World Forum for Harmonization of Vehicle Regulations

Proposal for the 04 series of amendments to UN Regulation No. 117 (Tyre rolling resistance, rolling noise and wet grip)

Submitted by the Working Party on Noise and Tyres*

"Annex 2 - Appendix 1

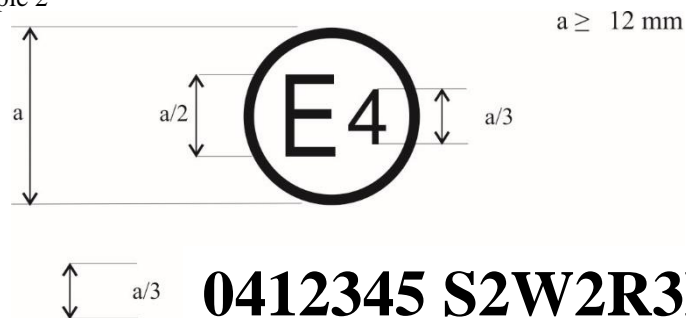
Appendix 1, amend to read:

The above approval mark, affixed to a pneumatic tyre shows that a tyre concerned has been approved in the Netherlands (E 4) pursuant to Regulation No. 117 (marked by S2 (rolling sound at stage 2) only), under approval number 0412345. The first two digits of the approval number (04) indicate that the approval was granted according to the requirements 04 series of amendments to this Regulation.

"Annex 2 - Appendix 2

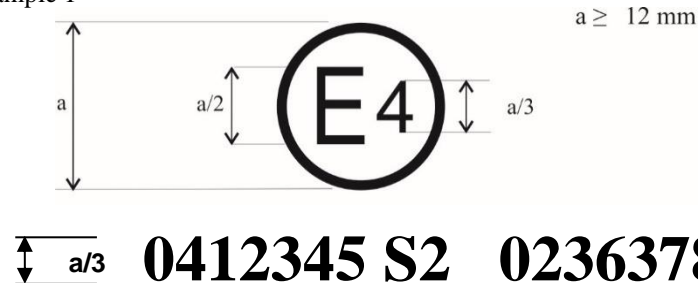
Appendix 2, amend to read:

The above approval mark shows that the tyre concerned has been approved in the Netherlands (E 4) pursuant to UN Regulation No. 117 (marked by "S2" (rolling sound at stage 2)), under approval number 0412345 and UN Regulation No. 30, under approval number 0236378. The first two digits of the approval number ("04" and "02") indicate that the approval was granted according to the 04 series of amendments and the approval pursuant to UN Regulation No. 30 according to the 02 series of amendments.

Example 2

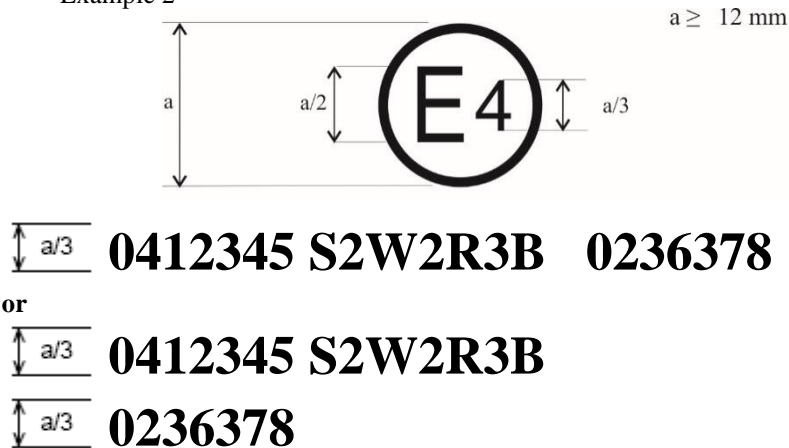
The above approval mark shows that the tyre concerned has been approved in the Netherlands (E 4) pursuant to Regulation No. 117 (marked by "S2W2R3B" (rolling sound emission at stage 2, wet adhesion of tyres in new state at stage 2, rolling resistance at stage 3 and wet adhesion of tyres in worn state)), under approval number 0312345 and UN Regulation No. 30 under approval number 0236378. The first two digits of the approval numbers ("04" and "02") indicate that the approval pursuant to UN Regulation No. 117 was granted according to the 04 series of amendments and the approval pursuant to UN Regulation No. 30 according to the 02 series of amendments."

Example 3

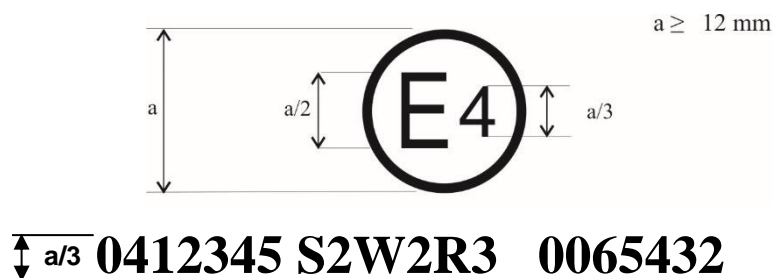
The above approval mark shows that the tyre concerned has been approved in the Netherlands (E4) pursuant to UN Regulation No. 117 (marked by "S2W2R3" (rolling sound emission at stage 2, wet adhesion of tyres in new state at stage 2 and rolling resistance at stage 3)), under approval number 0412345 and UN Regulation No. 54 under approval number 0065432. The first two digits of the approval numbers ("04" and "00") indicate that the approval pursuant to UN Regulation No. 117 was granted according to the 04 series of amendments and the approval pursuant to UN Regulation No. 54 according to its original form."

"Annex 2 - Appendix 3

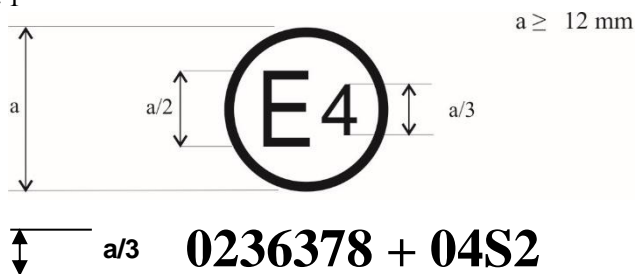
Appendix 3, amend to read:

The above approval mark shows that the tyre concerned has been approved in the Netherlands (E4) pursuant to UN Regulation No. 30 according to its 02 series of amendments (indicated by the first two digits of the approval number, "02") under approval number 0236378. It is also marked by "+ 04S2" which indicates that the tyre was also approved pursuant to UN Regulation No. 117 (04 series of amendments) for S (rolling sound emission at stage 2).

Example 2

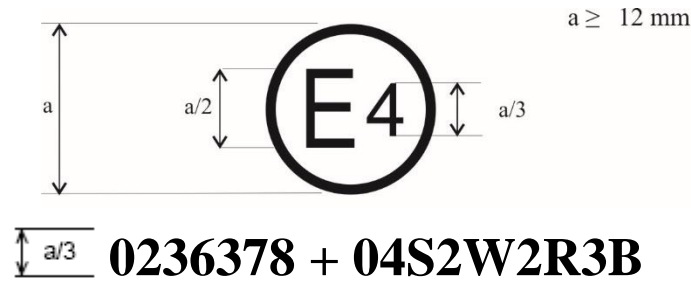
The above approval mark shows that the tyre concerned has been approved in the Netherlands (E4) pursuant to UN Regulation No. 30 according to its 02 series of amendments (indicated by the first two digits of the approval number, "02") under approval number 0236378. It is also marked by "+ 04S2W2R3B" which indicates that the tyre was also approved pursuant to UN Regulation No. 117 (04 series of amendments) for S (rolling sound emission at stage 2) W (wet adhesion of tyres in new state at stage 2), R (rolling resistance at stage 3) and B (wet adhesion of tyres in worn state)."

"Annex 2 - Appendix 4

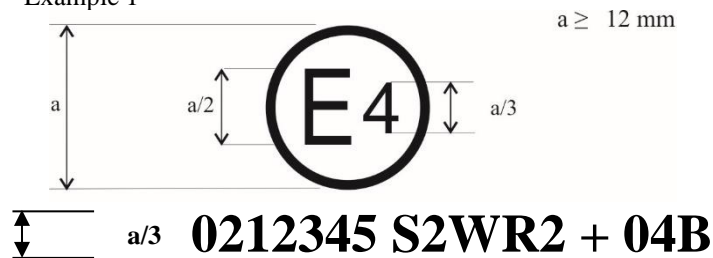
Appendix 4, amend to read:

The above approval mark shows that the tyre concerned has been initially approved in the Netherlands (E4) pursuant to UN Regulation No. 117 and the 02 series of amendments under approval number 0212345. The marking is complemented by S2WR2 (rolling sound emission at stage 2) W (wet adhesion of tyres in new state) and R (rolling resistance at stage 2). The "04B" preceded by "+" indicates that it has had its approval extended under UN Regulation No. 117 and 04 series of amendments to wet adhesion of tyres in worn state based on separate certificate."
